UNITED STATES PATENT AND TRADEMARK OFFICE

APPLICATION NO.	FILING DATE	FIRST NAMED INVENTOR	ATTORNEY DOCKET NO.	CONFIRMATION NO.
09/922,057	08/03/2001	Charles Arthur Risdall	38572/26217	7578

Office Action Summary

DETAILED ACTION

FIG. 7

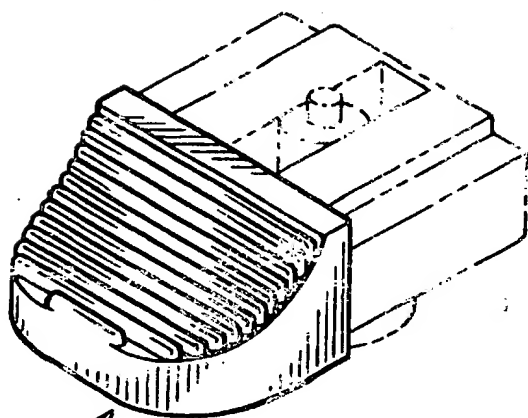
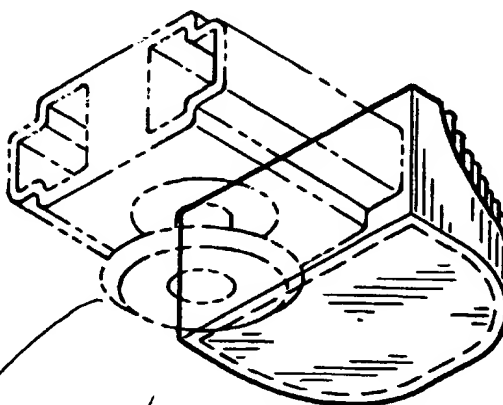
Schwartz discloses an end cap for closing an open end of a piece of furniture comprising a butt portion and an attachment portion (see attached marked-up drawings), the bottom side of the attachment portion having a threaded insert, such as shown in Fig 7, a threaded glide member

butt portion

attachment portion

threaded glide member
